SUBJECT: ISSUANCE OF AMENDMENT NO. 147 TO FACILITY OPERATING LICENSE
 NPF-38 - WATERFORD STEAM ELECTRIC STATION, UNIT 3 (TAC NO.
 MA3382)

AMENDMENT TO FACILITY OPERATING LICENSE

Amendment No. 147
License No. NPF-38

SAFETY EVALUATION BY THE OFFICE OF NUCLEAR REACTOR REGULATION

FIGURE 3.1-1

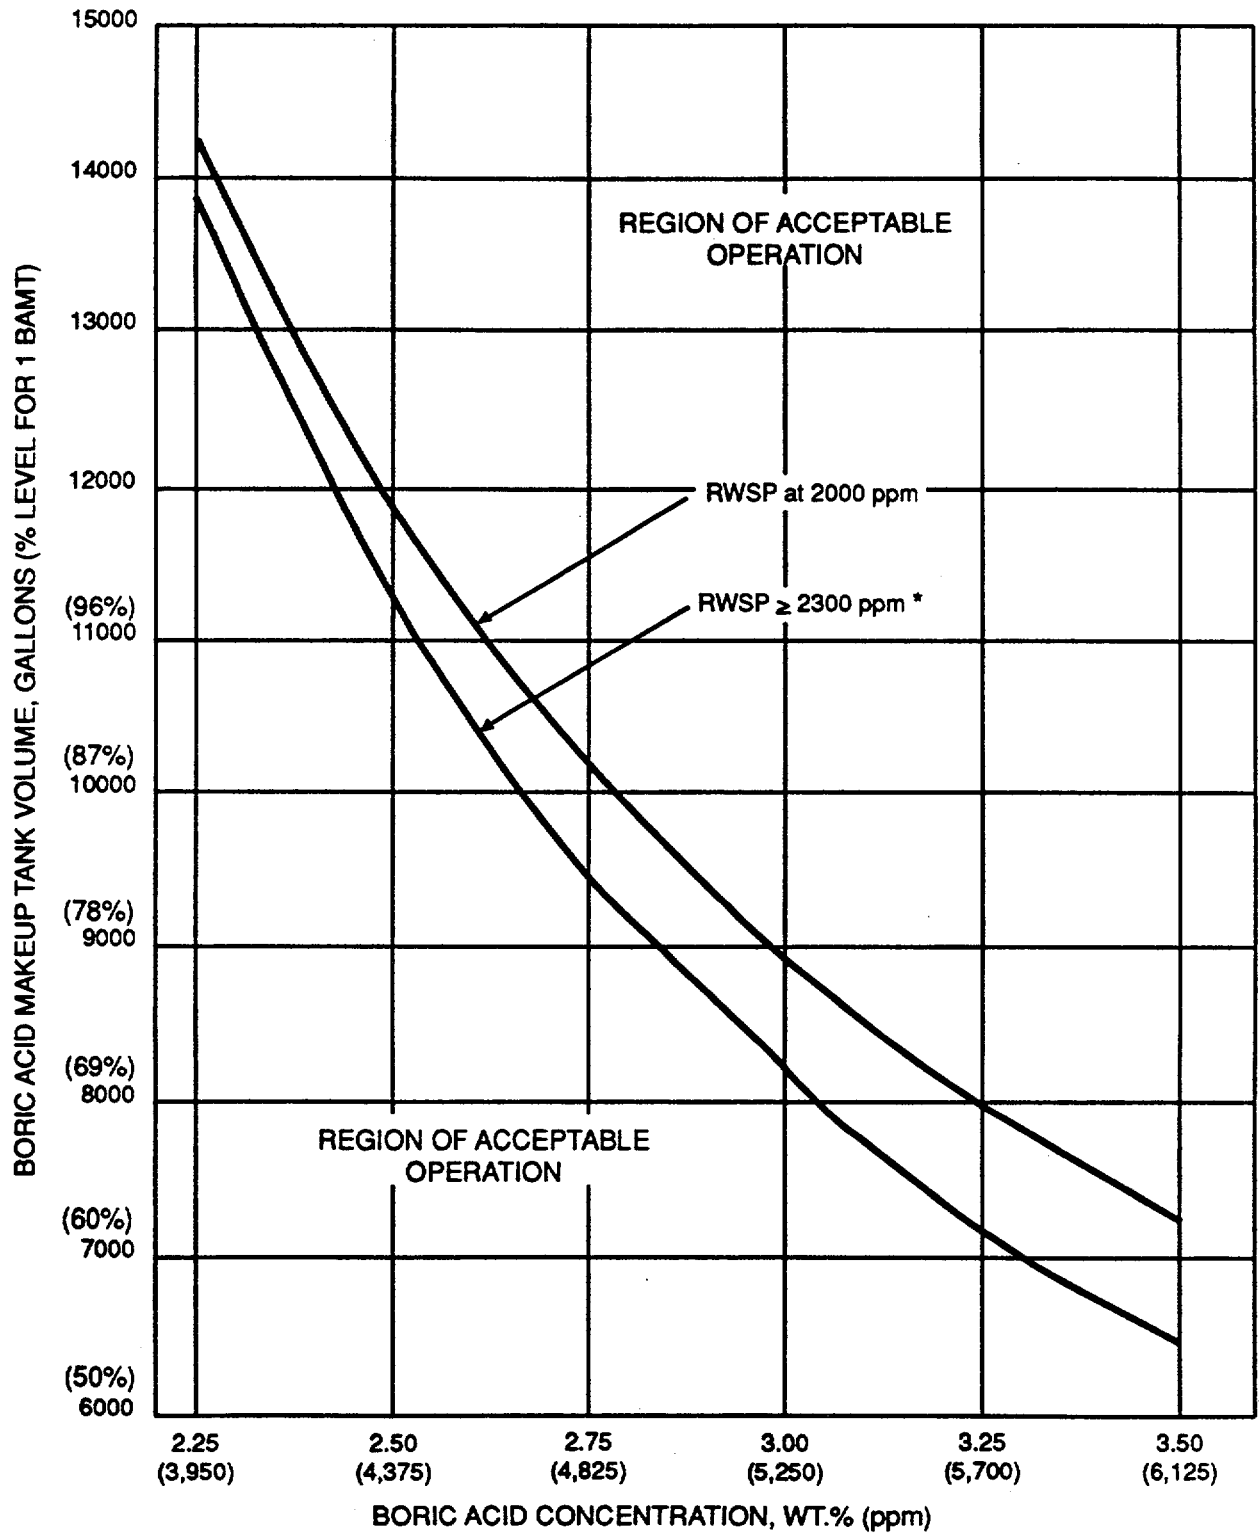
* This curve bounds RWSP concentration ranging from 2300 ppm to 2900 ppm

Figure 3.1-1, "Required Stored Boric Acid Volume as a Function of Concentration," defines the acceptable regions of operation for the available volume in the BAMT as a function of the boric acid concentration. As indicated in the figure for the RWSP concentration of 2300 ppm, the volume needed in the BAMT to ensure adequate shutdown margin increases with decreasing boric acid concentration. The plot for an RWSP concentration of 2900 ppm will lie below the plot for a boric acid concentration of 2300 ppm indicating that, for each boric acid concentration in the BAMT, less volume from the BAMT is needed to ensure adequate shutdown margin due to the increased availability of boron. The licensee proposes to use the plot of the RWSP boric acid concentration of 2300 ppm as the limit for boric acid concentrations greater than and equal to 2300 ppm. This change conservatively bounds the proposed increase of boric acid concentration of 2900 ppm in the RWSP.
